**Analysis of Public Comments on Draft Regulatory Issue Summary 2015-02,
“Reporting of H-3, C-14, Tc-99, and I-129 on the Uniform Waste Manifest”**

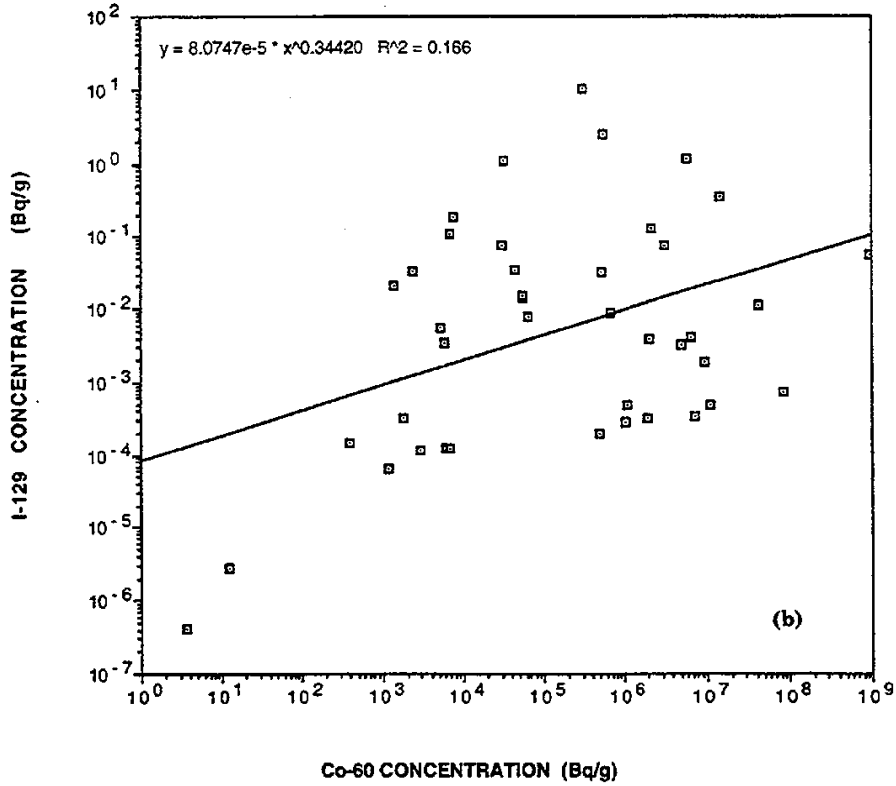
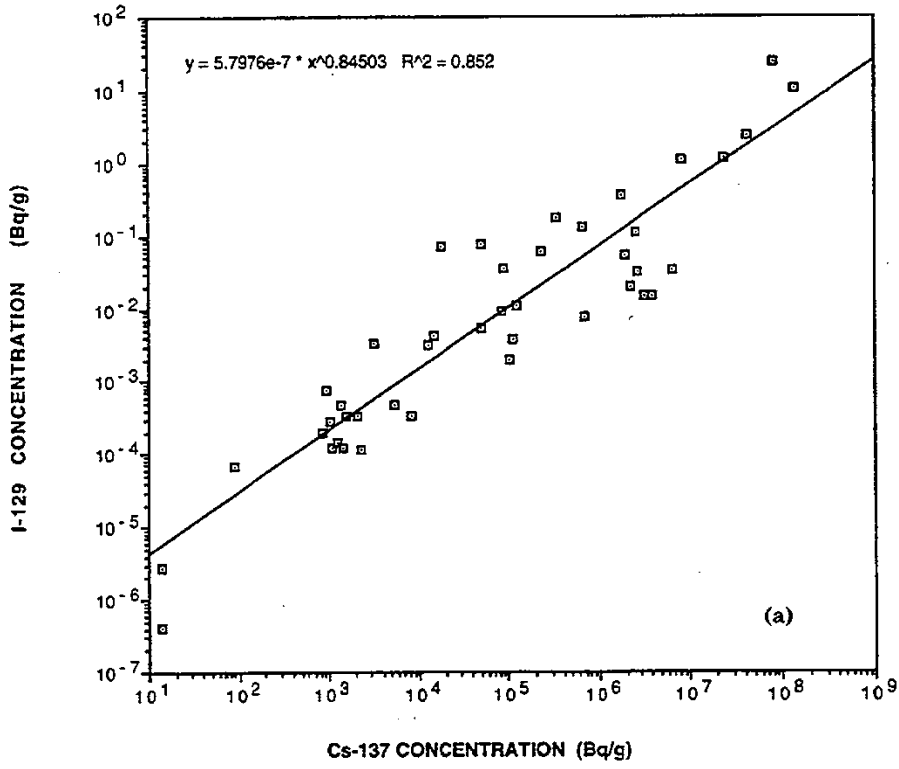
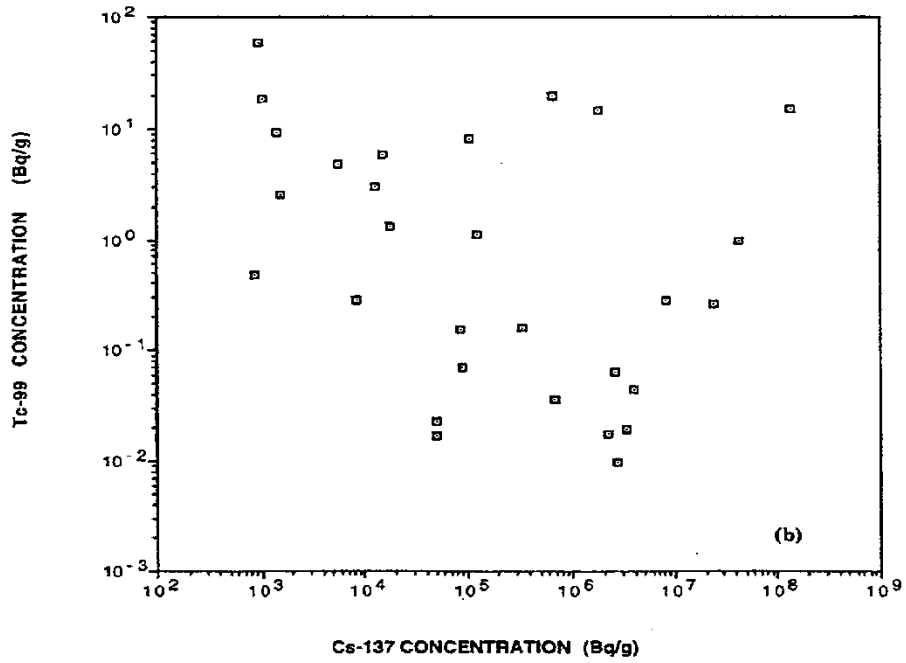
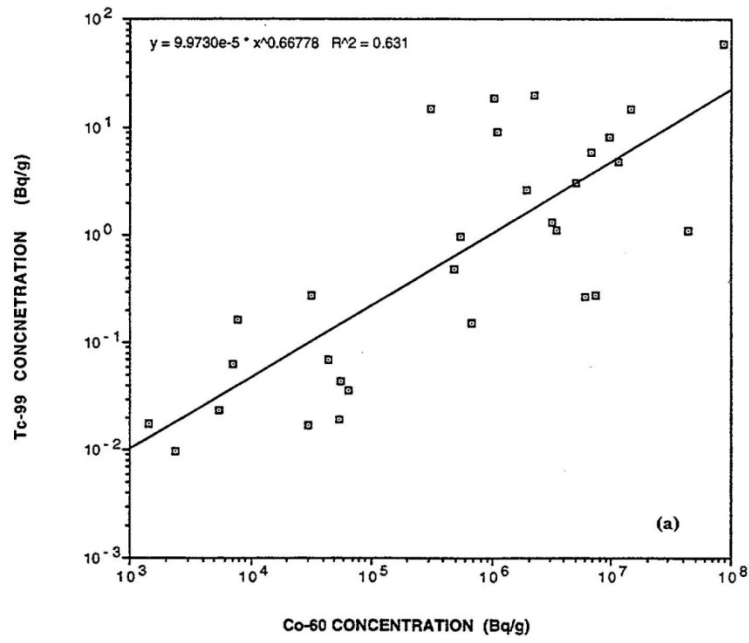
Comment: Three commenters discussed the use of generic scaling factors to quantify hard-to-detect radionuclides. One of these commenters suggested that the nuclear industry should adopt methods to allow for more precise estimation of the nuclides. This commenter stated that the Electric Power Research Institute

(EPRI) has amassed a large amount of data from the operating nuclear facilities in the US and has been able to make some correlations that will provide some basis for potential generic scaling factors for Tc-99 and I-129. The commenter believes that the use of this information is a potential resolution to the issue of overestimation.

The other two commenters suggested that the RIS should be edited to specifically allow for the use of scaling factors developed by EPRI based on samples analyzed using mass spectrometry (MS). These commenters indicated that the industry scaling factors had been derived using the dispersion method, and both suggested that this was the appropriate statistical method for evaluating a data set with a large variation. Additionally, the commenters noted that the use of generic scaling factors should be evaluated for change when a large fuel defect is present.

The MS analyses performed by PNNL referred to in these comments are documented in NUREG/CR-6567. In the research documented in this report, a variety of low level waste samples were obtained from commercial nuclear power reactors. The activities of Tc-99 and I-129 in these samples were measured using the highly sensitive MS methods. The sample results are listed in Table 7.8 of NUREG/CR-6567 and include 45 samples from both BWR and PWR plants. The types of waste sampled include resin, dry active waste, filters, charcoal, soil, lubricating oil, and reactor coolant. As is shown in Table 7.8, the ratios of I-129 and Tc-99 to Co-60 and Cs-137 were calculated for each sample. Geometric means of these ratios were also calculated for each radionuclide pair. Scatter plots of the concentrations of I-129 and Tc-99 versus Co-60 and Cs-137 from NUREG/CR-6567 are reproduced below.

The figures above revealed a degree of I-129 and Cs-137 correlation and a degree of Tc-99 and Co-60 correlation, but correlations between I-129/Co-60 and Tc-99/Cs-137 were not observed. The lack of correlation may be due to differences in the production mechanism of these radionuclides (i.e., I-129 and Cs-137 are fission products while Co-60 is an activation product and Tc-99 is both a fission and an activation product). The NRC staff believes that the lack of correlation may also be due to the fact that many waste types and plant types are included in this data set. A better correlation may be seen for data sets that include similar waste streams from similar plant types. The research in NUREG/CR-6567 is therefore not adequate on its own to support a generic scaling factor. More research is needed to understand the correlations between these radionuclides in different waste streams and the range of conditions under which the correlations are applicable. Additionally, this study only included 45 samples that were taken between 1988 and 1996; more sample data, including more recent samples, are needed to supplement the research in the NUREG/CR.

NRC staff has not seen information that demonstrates that these correlations are improved when a particular statistical method is used. If such information exists, any person may voluntarily submit this information to the NRC for its review.
